PROJECT INFORMATION

site address	3405/3411/3417 Harbor Ave SW
parcel numbers	7987400130, 7987400140, 7987400150
project number	3034147-EG

Scheme 3: INTERLOCK (PREFERRED)

section a

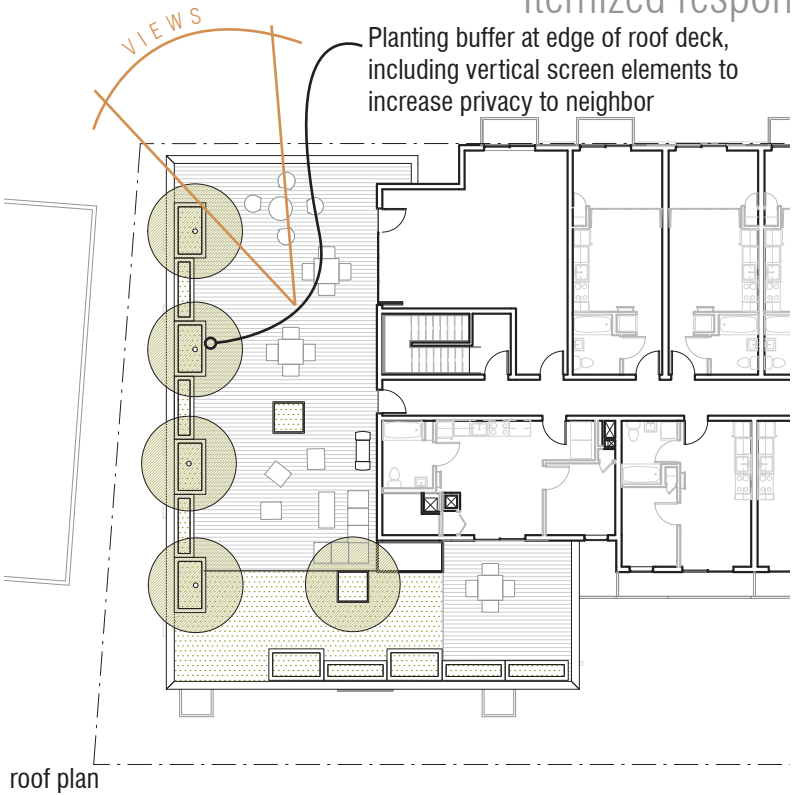
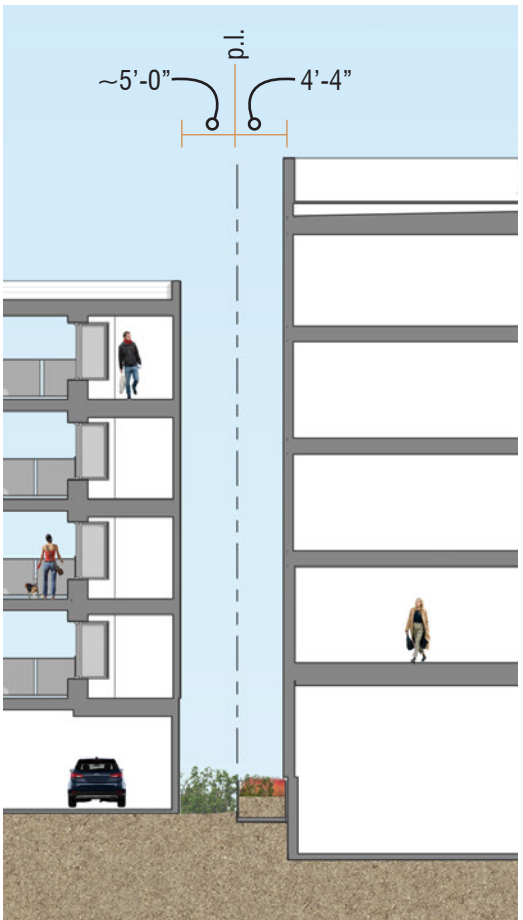
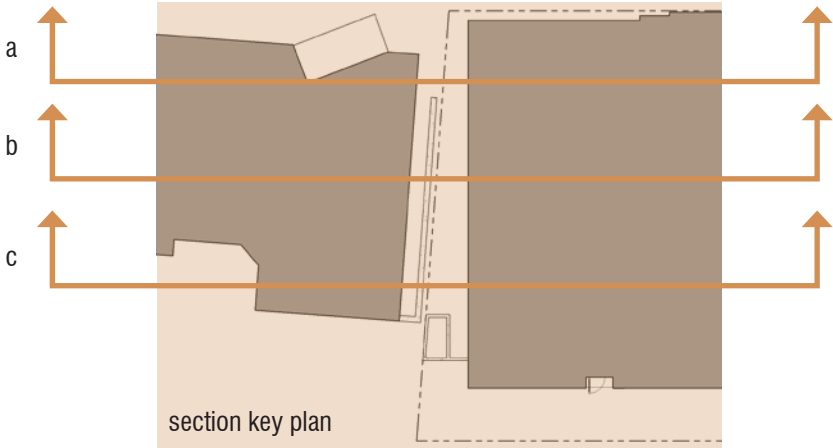
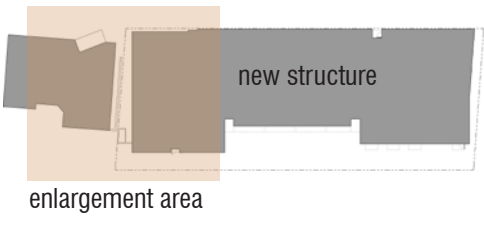
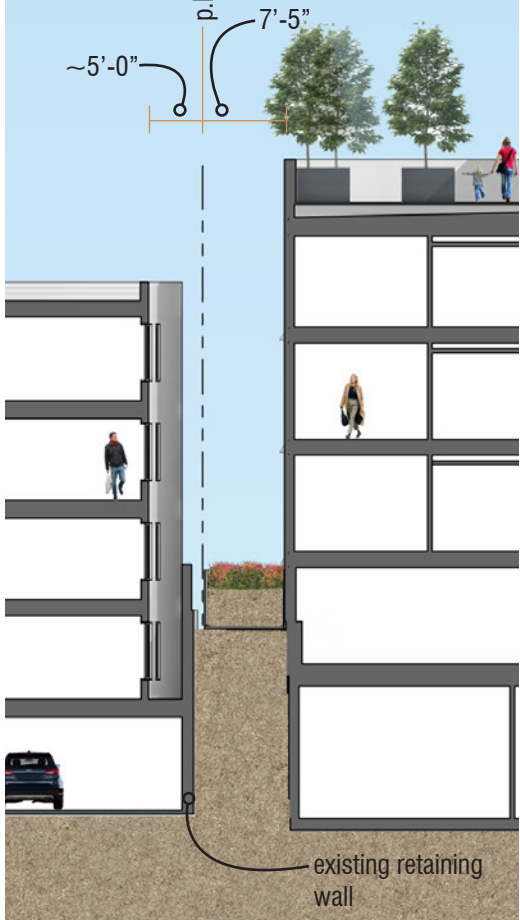
North Edge - Echoing public comment, the Board was unclear on the relationship of the proposed massing to the adjacent building to the north. At the next meeting, clarify this condition with sections and window privacy studies. In addition, the Board noted it may be more beneficial to provide a step down in massing at this edge than at the south end and would expect to see exploration of this at the next meeting (CS2-D5).

- Previously, the massing was located 5' from the property line on the north side, and was a full 5 stories over a basement tall. In response to the Board's guidance and neighborhood comments, building has been shifted and now tapers from 4'-4" (adjacent to the section of blank wall) to 7'-5" (adjacent to neighboring windows) from the shared property line. Landscaped planters/bioretention planters have been located between the building and property line edge to further mitigate the impact of the building.

- The massing has been modified to step down at the northern edge, in response to the neighboring building.
- Glazing on the north façade has been minimized and studied to avoid conflict with the neighboring windows as much as possible, and per neighborhood comment no private balconies are proposed along this facade.

- A landscape buffer including trees is provided on the roof deck to screen the neighboring property from the public amenity space, keeping residents away from the edge and further from the neighboring structure.

The new structure is held off the property line and moves further away from the existing structure as it moves west, providing the greatest distance between buildings where the neighboring structure's windows are located.

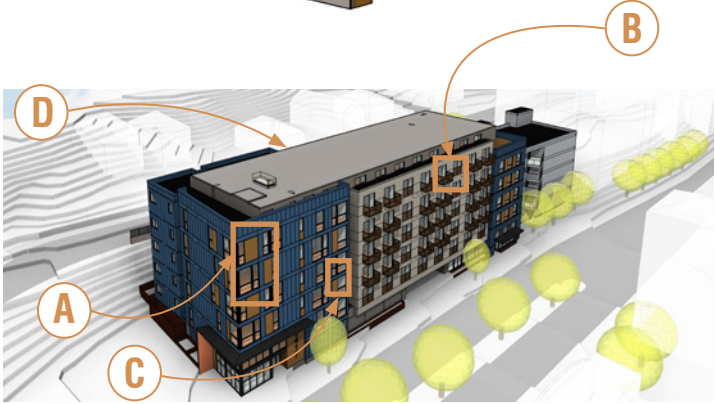
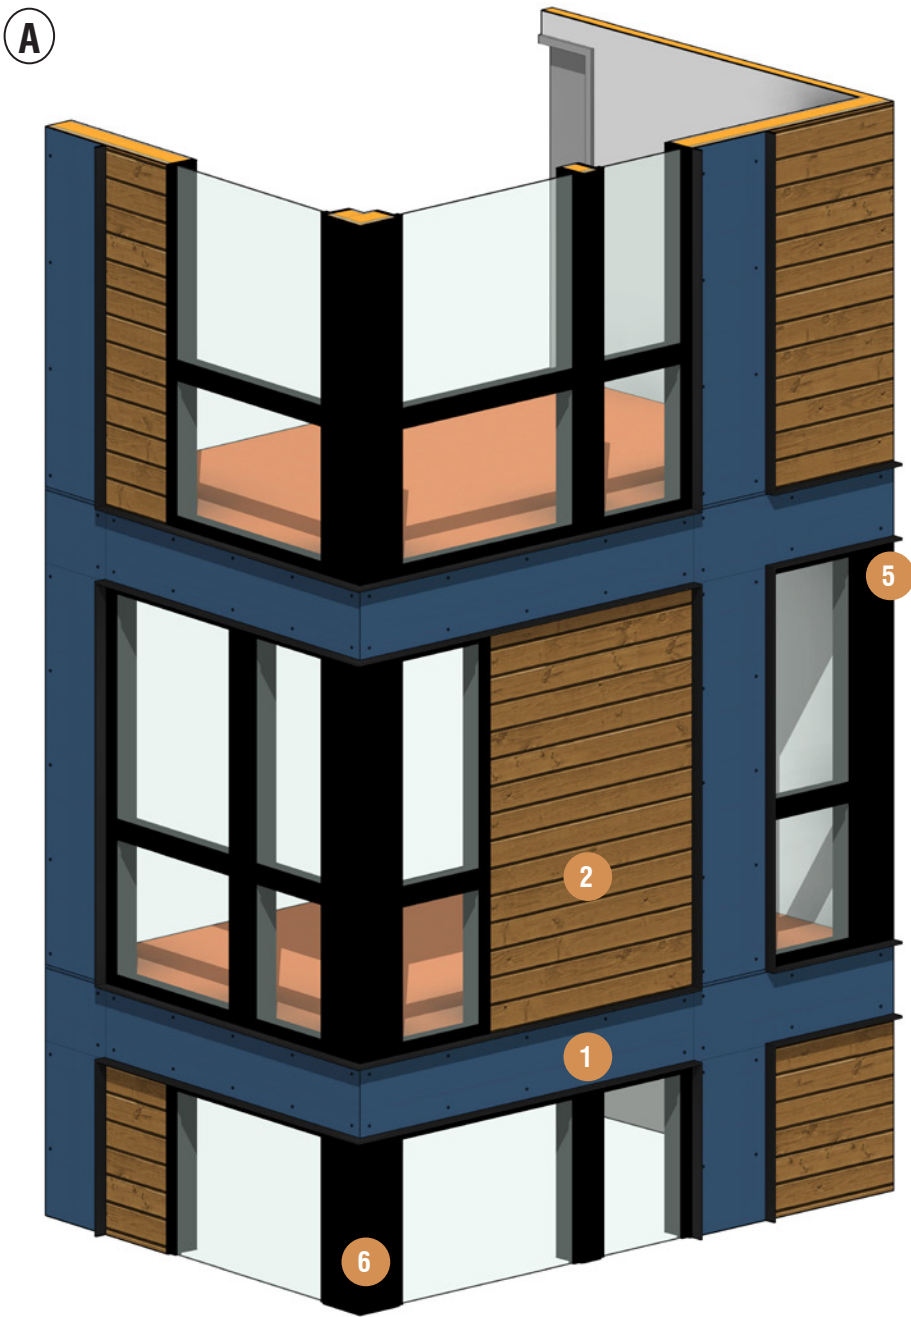
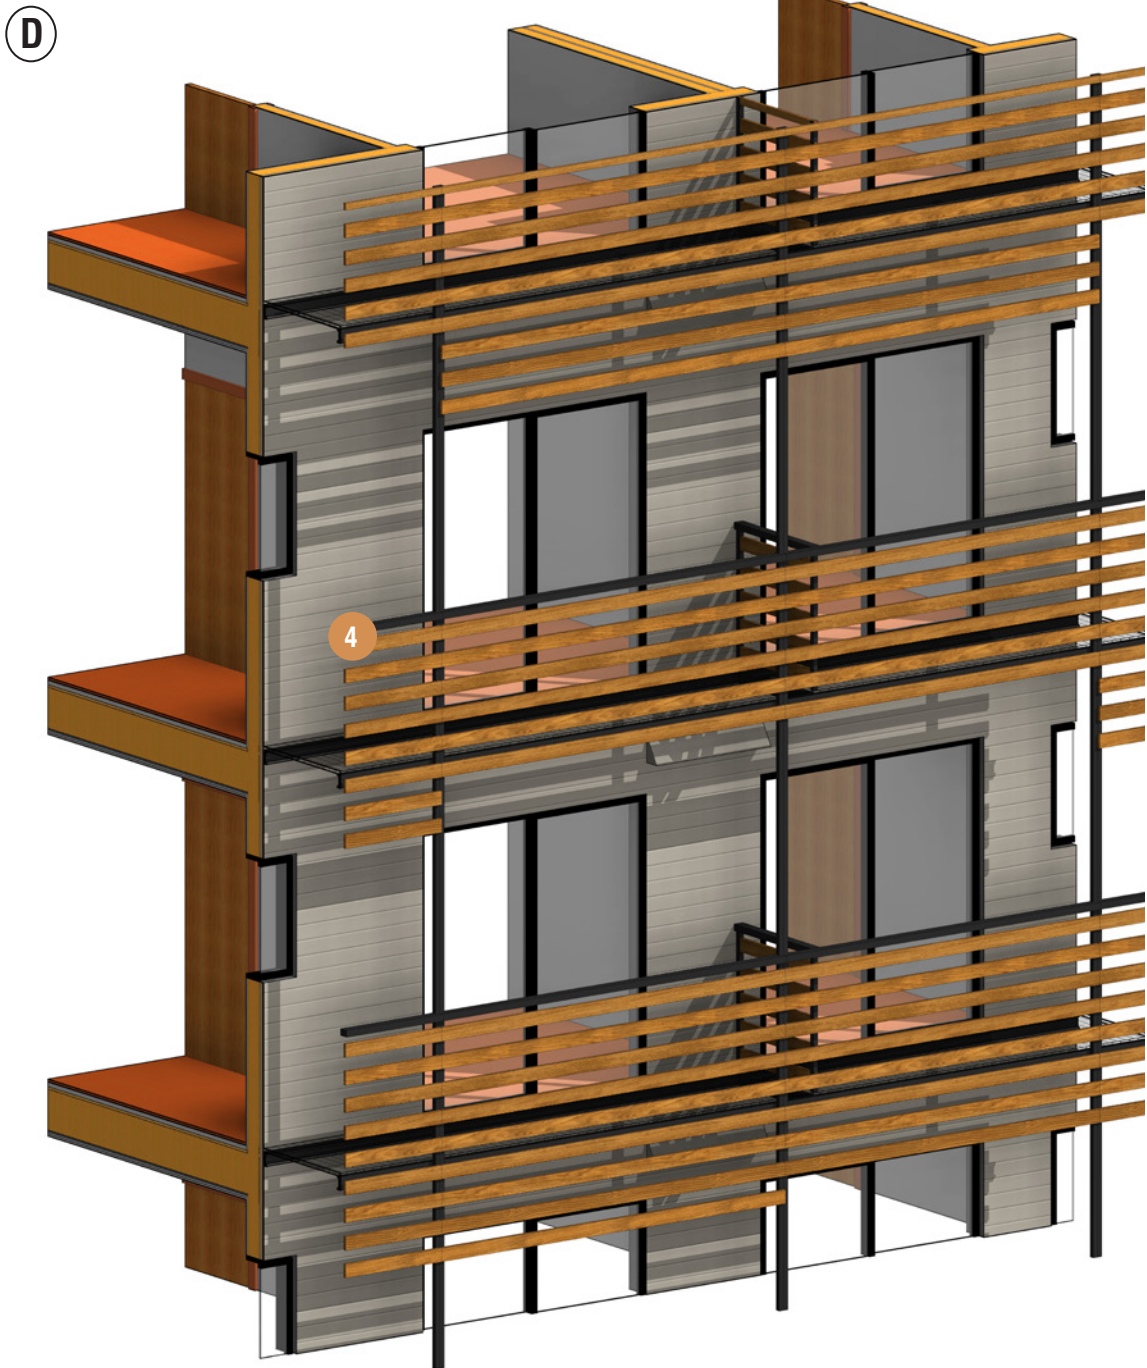
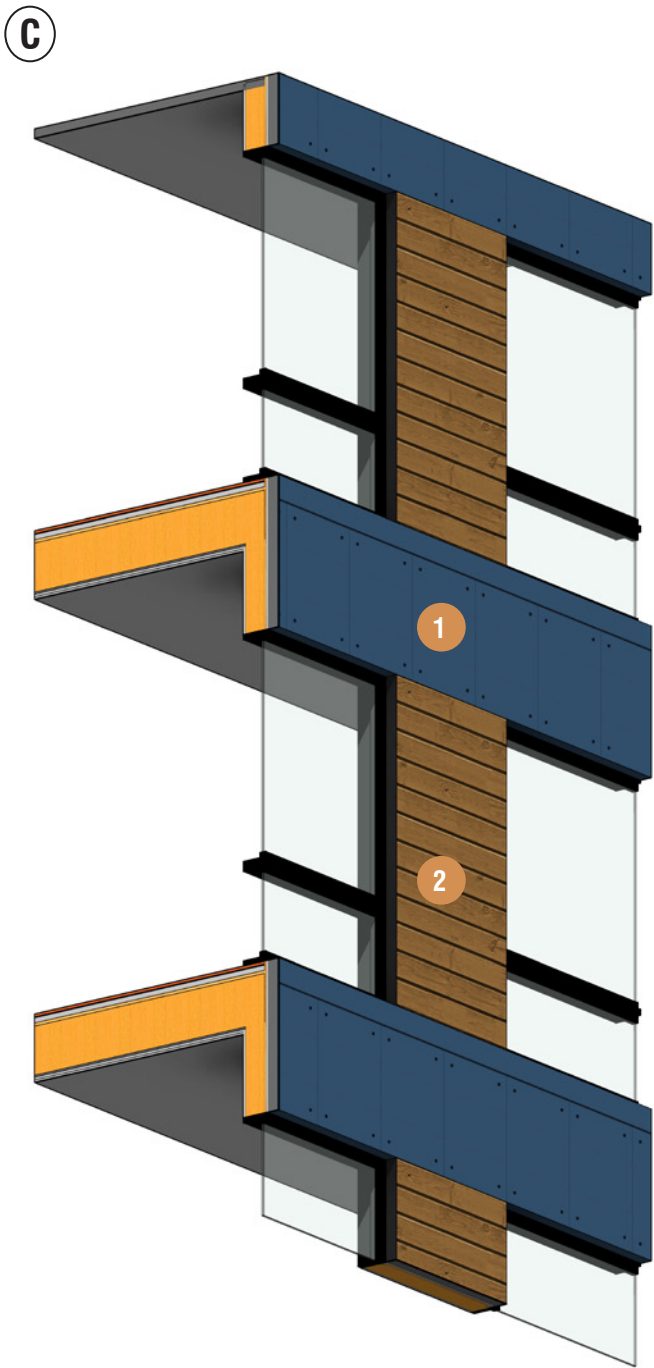
Materials - As noted above, the Board expects to see material application and detailing which further breaks down the height, bulk, and scale of the simple massing form (DC2-B1, DC2-C1, DC4-A1).

The project continues to explore material options and detailing to break down the building’s massing. Regimented panel seams and a lively window pattern are used to create a playful expression at the north corner. The remainder of the north and south nodes uses the same material palette, but with an offset panel seam pattern and regimented windows and doors. At the center interlocking bar form, simple window patterns and plank siding quiet this center mass. The use of wood railings and screens further reinforces the residential scale. The architectural expression of the north and south nodes are further distinguished from the center mass through the detailing.

- Windows and doors on the north and south node are recessed to provide an expression distinct from the center interlocking mass.
- Careful attention has been made to apply a logical panel seam rhythm to the windows, particularly at the southwest corner element where all windows and wood panels fit within the panel seams.

- The scale of the siding at the central mass reflects the adjacent residential neighborhood, allowing the north and south nodes to act as anchoring masses.

- The gaskets along Harbor Ave are fully expressed (without balconies disguising the change in plane) which contribute to a massing concept scaled appropriately to fit with the industrial and commercial zones it abuts. Alternatively, the gaskets along 30th Ave are connected to the longer balcony expression in response to the residential scale of the adjacent zone.
